## Response Document - Beverley Four Mile Project PER and Mining Lease Proposal

19 March 2009

Date: 19 March 2009  
Reference: 42657105.05002  
Status: Final Report

Figure 3-2 Annual Pan Evaporation and Rainfall, Beverley

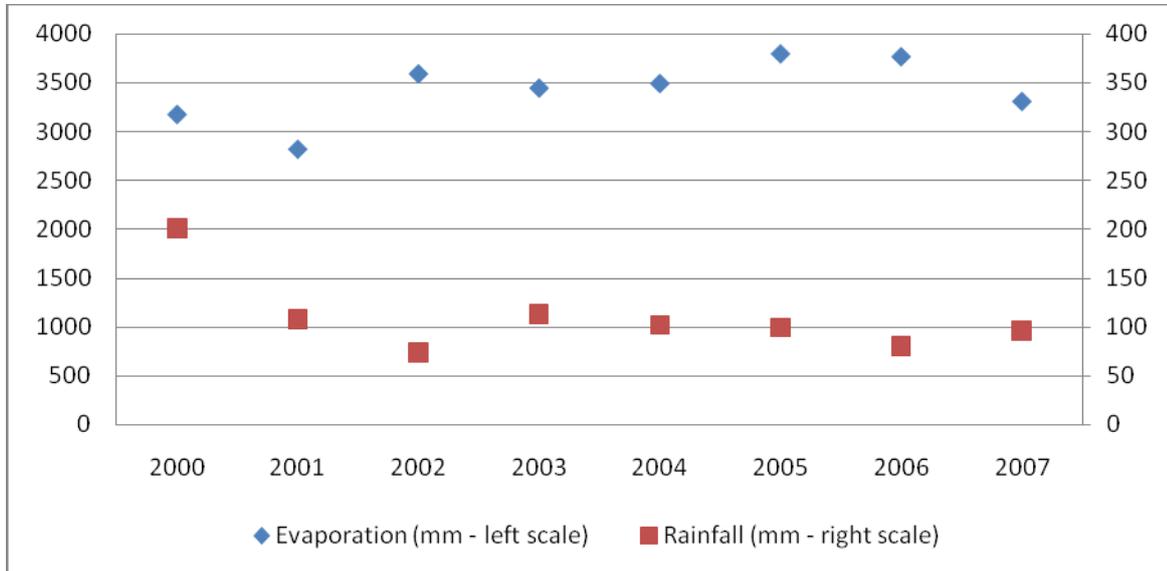
Figure 3-2 was missing from the final electronic (pdf) version of the document. It is presented below:
